ADDENDUM No. ONE

Date: June 11, 2024

Project: Flemington Road Improvements, MES No. 2023-80

C201

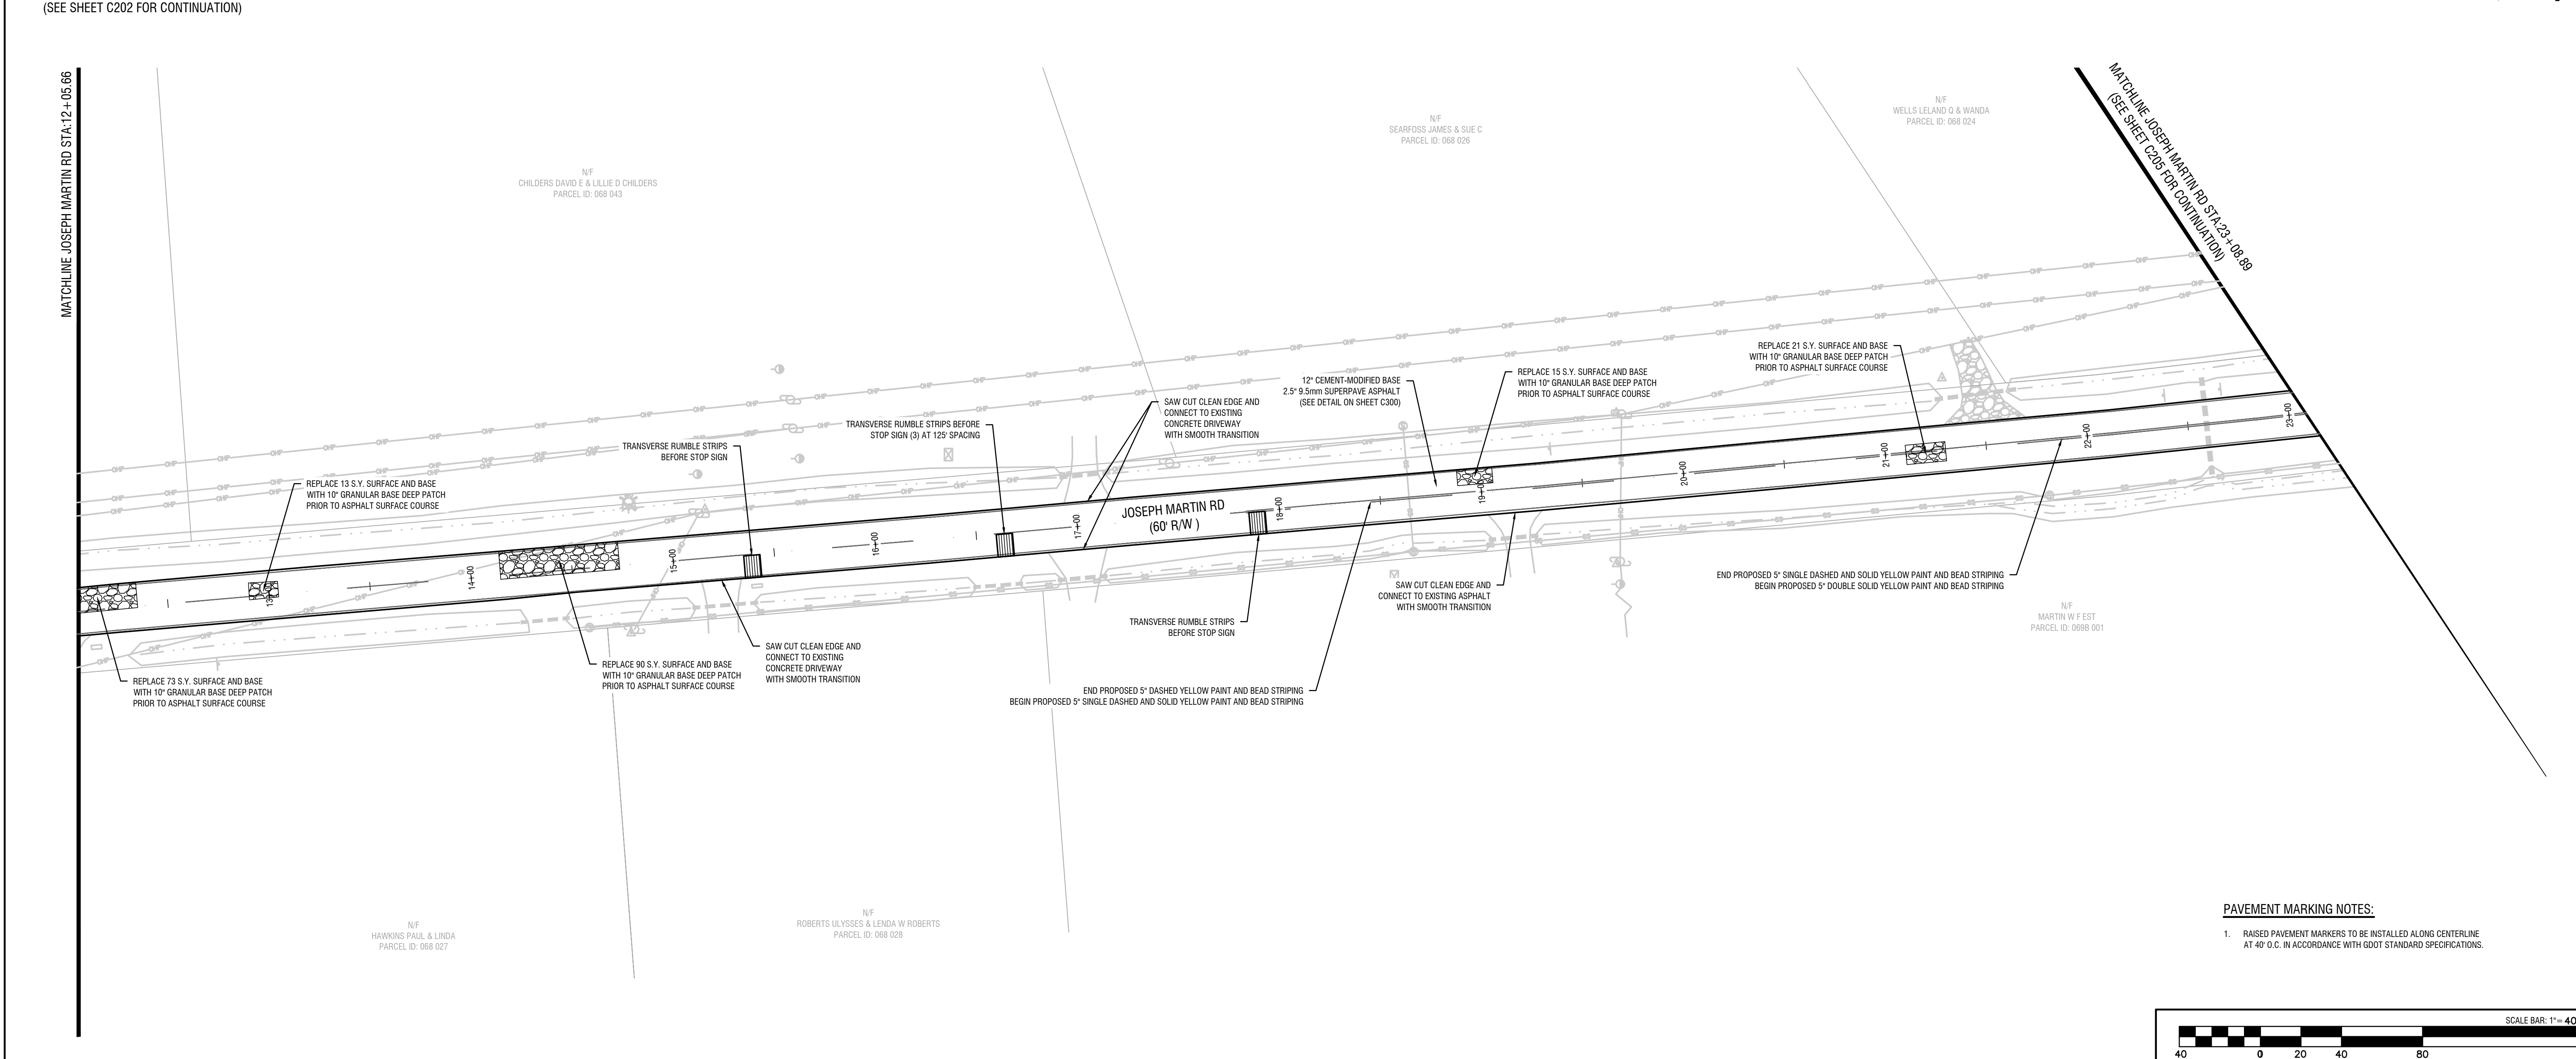
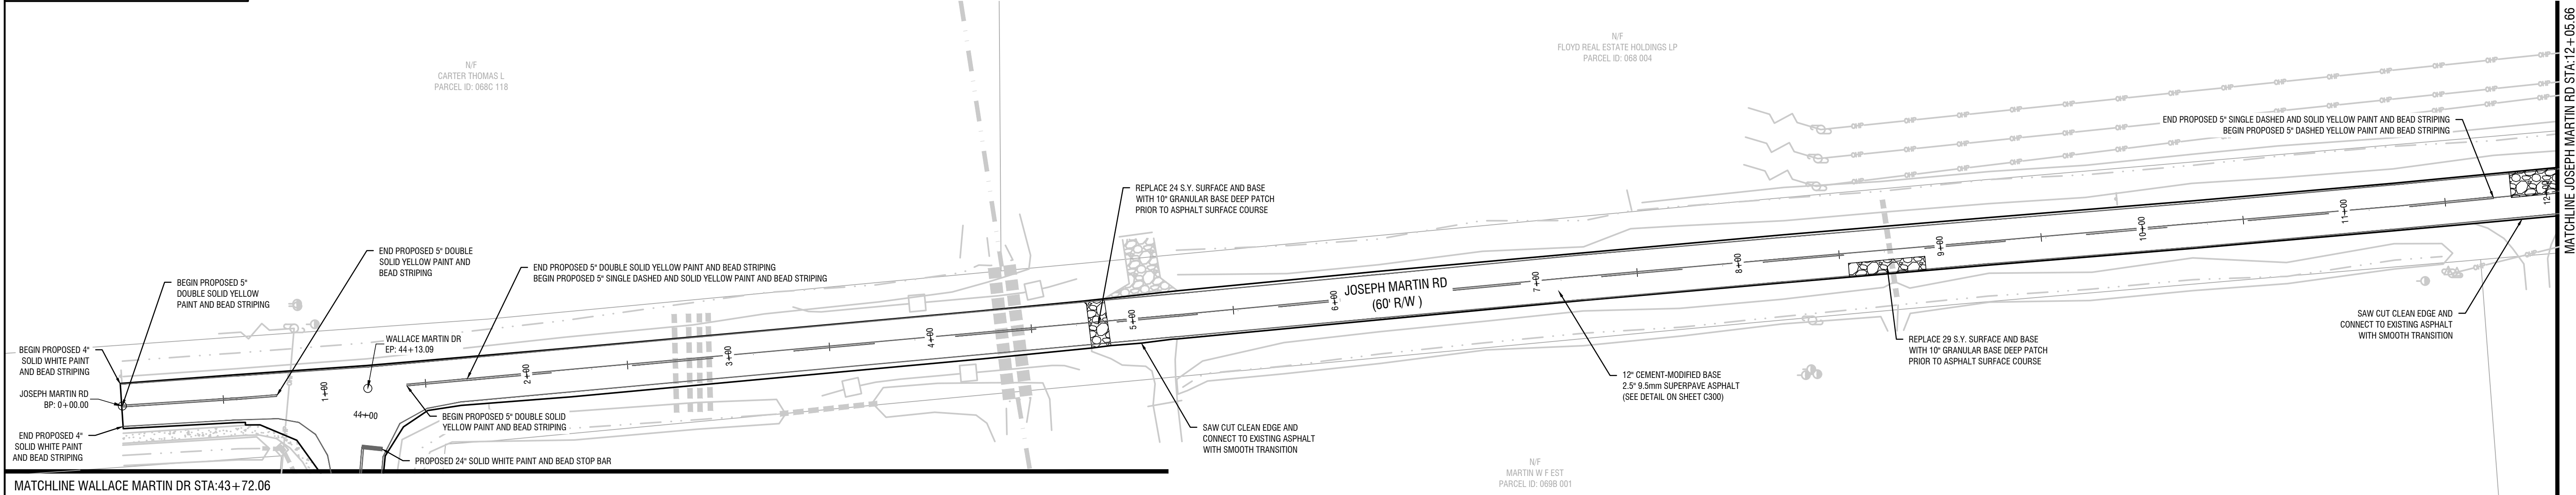
- Replace previous Sheets C201 – C300 with enclosed of the same. Note the Engineer has decided to add rumble strips and raised pavement markers for vehicular safety, given that the existing measures will be removed during construction.

1. RAISED PAVEMENT MARKERS TO BE INSTALLED ALONG CENTERLINE AT 40' O.C. IN ACCORDANCE WITH GDOT STANDARD SPECIFICATIONS.
